Contract #: 04-0120F4Cty: SF/ALA Rte: 80 PM: 13.2/13.9File #: 69.25B**QUALITY ASSURANCE -- NON-CONFORMANCE REPORT****Location:** Changxing Island, Shanghai, P.R. China**Report No:** NCR-000289**Prime Contractor:** American Bridge/Fluor Enterprises, a JV**Date:** 30-May-2009**Submitting Contractor:** Zhenhua Port Machinery Company, Ltd (ZPMC), Changxing Island**NCR #:** ZPMC-0263**Type of problem:****Welding****Concrete****Other****Welding****Curing****Procedural****Bridge No:** 34-0006**Joint fit-up****Coating****Other****Component:** Deck Panel DP048A, Segment 4BE**Procedural****Procedural****Description:****Reference Description:** Tack Weld Removal MT Indications, Segment 4BE**Description of Non-Conformance:**

Dear: Mr. Charles Kanapicki
Job Name: SAS Superstructure

Subject: NCR No. ZPMC-0263

Reference Description: Tack Weld Removal MT Indications, Segment 4BE

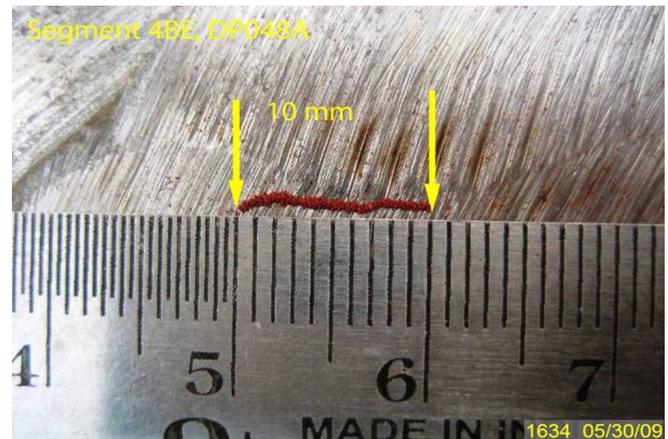
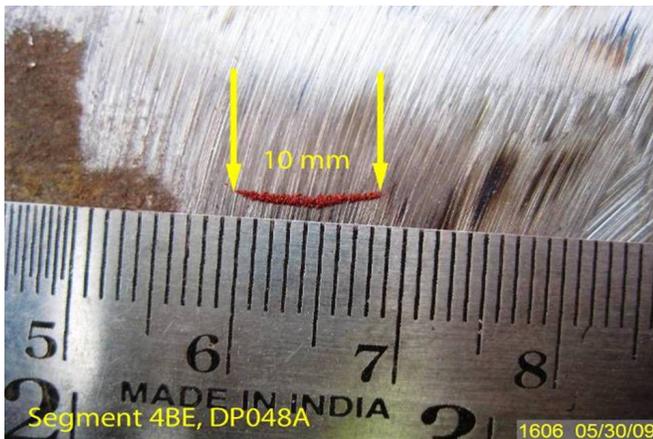
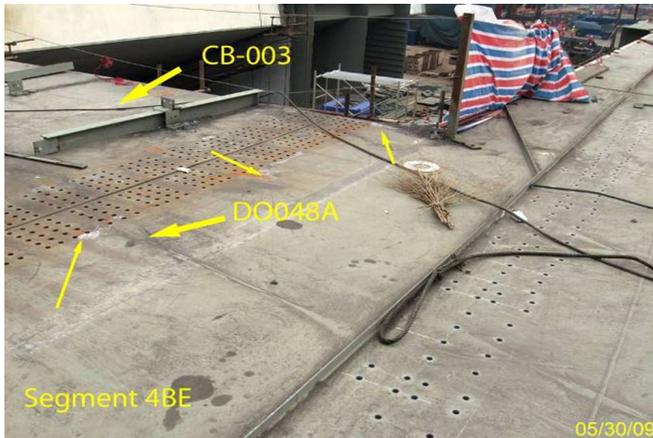
Caltrans Quality Assurance Inspector detected 5 linear indications in the base metal of Deck Panel DP048A in Segment 4BE during random magnetic particle testing (MT) of tack weld removal locations. The tack welds were made to hold the splice plate in place while match drilling the segment deck and crossbeam (CB3) in the trial assembly.

AWS D1.5, 2002 Section 3.3.7.4 - "The removal of tack welds may expose unacceptably hard or cracked HAZs. Such areas on members subject to tension or reversal-of-stress shall be tested by MT (preferably by the yoke method) to assure that no cracks are present."

AWS D1.5, 2002 Section 6.26.2 – "Welds that are subject to MT in addition to visual inspection shall have no cracks"

Please propose a resolution for the identified non-conformance to prevent future occurrences.

Component: Deck Panel DP048A, Segment 4BE

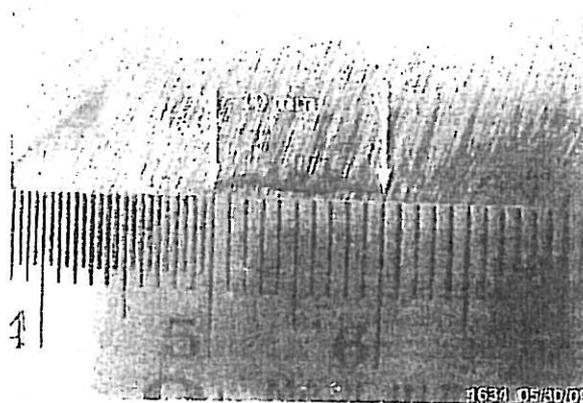
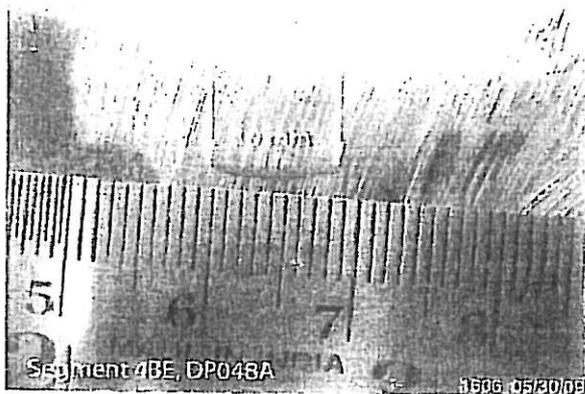
Caltrans Quality Assurance Inspector detected 5 linear indications in the base metal of Deck Panel DP048A in Segment 4BE during random magnetic particle testing (MT) of tack weld removal locations. The tack welds were made to hold the splice plate in place while match drilling the segment deck and crossbeam (CB3) in the trial assembly.

AWS D1.5, 2002 Section 3.3.7.4 - "The removal of tack welds may expose unacceptably hard or cracked HAZs. Such areas on members subject to tension or reversal-of-stress shall be tested by MT (preferably by the yoke method) to assure that no cracks are present."

AWS D1.5, 2002 Section 6.26.2 - "Welds that are subject to MT in addition to visual inspection shall have no cracks"

加州在抽查 4BE 顶板 DP48A 母材 MT 时,发现存在 5 处裂纹,这些裂纹位于箱梁与 CB3 联系梁连接板去除点焊位置.具体见下图所示:

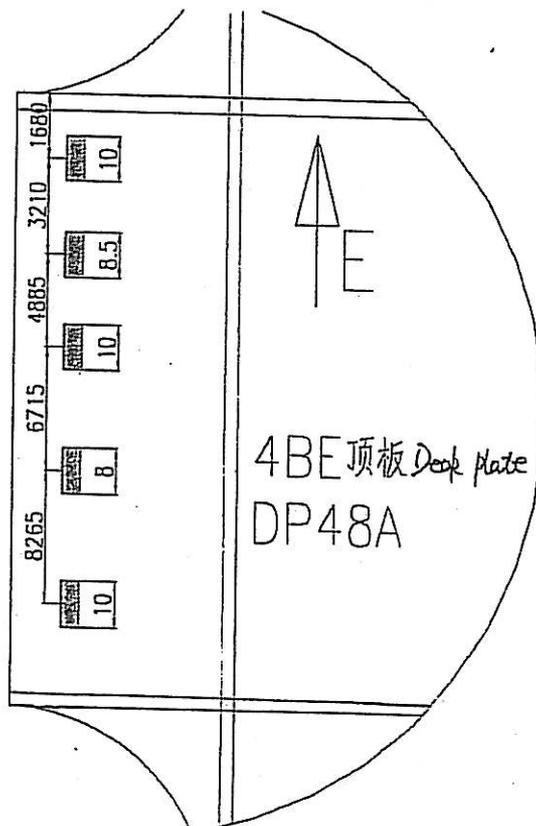
Five cracks were found out after CT performed a casual inspection to the base metal MT on 4BE deck plate DP48A. These cracks were located on the area where the tack welds between box and CB3 connection plate were removed.

The base metal was damaged when removing the lack welds between the box and CB3 connection plate.

1. QC and a Lead CWI shall be present and direct all grinding and welding operations during this repair.
2. QC and a Lead CWI shall have an approved copy of the CWR in hand prior to the repair.
3. QC and a Lead CWI shall direct the repair to ensure the repair is per the disposition requirements.
4. Prepare excavation according to the approved repair WPS;
5. Verify with VT and MT repair area is free of all defects.
6. Preheat and weld according to the relevant repair WPS;
7. Grind the repaired area flush with base metal;
8. Perform 100%VT and MT UT of repair area.
